FAQ Number		08-0054		FAQ Revision 0				
FA	Q Title	Demonstrating Compliance with Chapter 4 of NFPA 805						
Plant:	Ocone	e Nuclear Station	Date:	August 19, 2010				
Contact:	David	Goforth	Phone:	704-249-5607				
			Email:	David.goforth@duke-energy.com				
Distribution	: (NEI In	ternal Use)						
🛛 805 TF 🗌 FPWG 🗌 RATF 🗌 RIRWG 🗌 BWROG 🗌 PWROG								
Purpose o	of FAQ:							
Based on the revision to Regulatory Guide 1.205 (revision 1), lessons learned from the NFPA 805 Pilot Plants, additional guidance is needed to define the process of demonstrating compliance with Chapter 4 of NFPA 805.								
Is this Interpretation of guidance? Yes / No								
Proposed new guidance not in NEI 04-02? Yes / No								
Details:								
NELO4 02 muidence needing interpretation (include costion, nerospend, and line

Sections 4.3.2 and Appendix B Section B.2.2 need revision based on lessons learned during the pilot process

### FAQ Title Demonstrating Compliance with Chapter 4 of NFPA 805

- NEI 04-02 Section 4.3.2, Nuclear Safety Performance Criteria Transition Review, and
- Appendix B Section B.2.2, Establishing Compliance with Chapter 4 of NFPA 805.

#### Figure 4-3 - Fire Area by Fire Area Transition Process (Simplified)

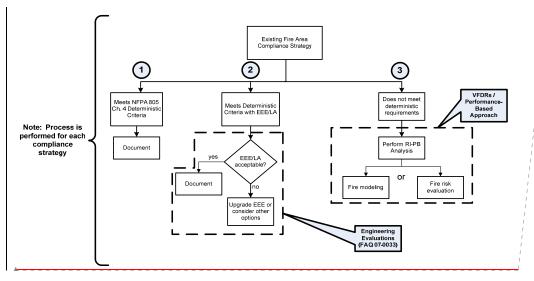
A simplified flowchart of the fire area by fire-area transition review is provided as Figure 4-3 below.

The review is intended to identify and document how compliance strategies for each fire area:

- 1. Align with the NFPA 805 Chapter 4 deterministic methods for meeting the nuclear safety performance criteria in NFPA 805 Section 1.5; or
- Align with the NFPA 805 Chapter 4 deterministic methods for meeting the nuclear safety performance criteria in NFPA 805 Section 1.5 with correctly implemented supporting engineering evaluations (Engineering Equivalency Evaluations or Licensing Actions); or
- 3. Do not align with the NFPA 805 Chapter 4 deterministic methods for meeting the nuclear safety performance criteria in NFPA 805 Section 1.5. Items that do not meet the deterministic requirements can be modified to bring into compliance or evaluated using risk-informed, performance-based methods as part of the transition.

#### Figure B-TBD1 – NFPA 805 Chapter 4 Compliance Assessment Process

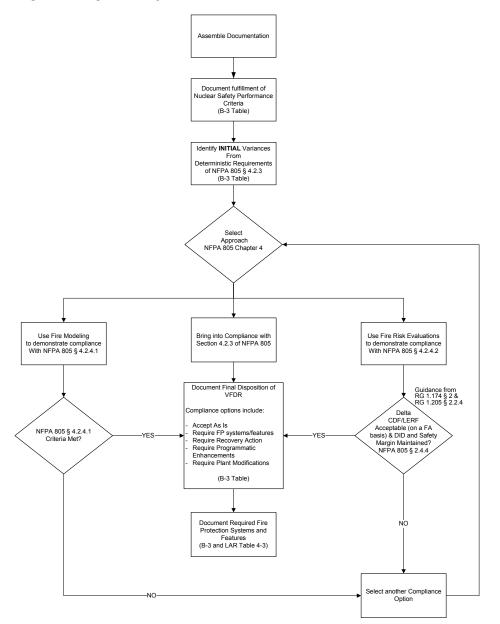
The process for determining compliance with Chapter 4 of NFPA 805 can be divided into the following steps:

- Step 1 Assemble documentation
- Step 2 Document Fulfillment of Nuclear Safety Performance Criteria
- Step 3 VFDR Identification, Characterization, and Resolution Considerations
- Step 4 Performance-Based Evaluations
  - o Fire Modeling Evaluations

- o Fire Risk Evaluations
- Step 5 Final VFDR Evaluation
- Step 6 Document Required Fire Protection Systems and Features

This process is depicted in Figure B-TBD1.

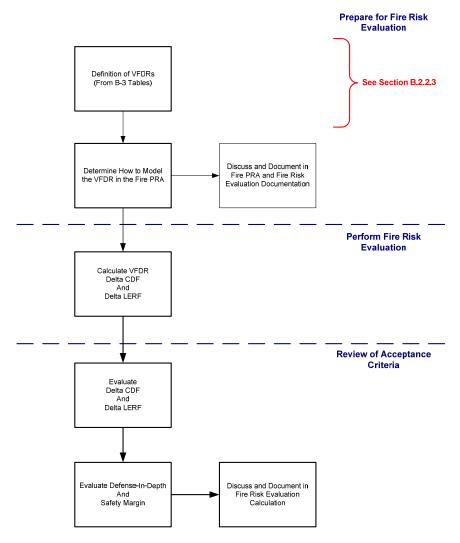
The following subsections describe the methodology used to prepare a FRE and to evaluate the results. Figure B-TBD2 is an outline of the FRE process during NFPA 805 transition.

The deterministically compliant condition is defined as that plant condition or configuration that is consistent with Section 4.2.3 of NFPA 805 (shown as Case 2 in Figure B-TBD3). The variant condition or configuration, either 'as found' or proposed by a plant change, that is not consistent

with Section 4.2.3 of NFPA 805, is defined as the variant condition (shown as Case 1 in Figure B-TBD3).
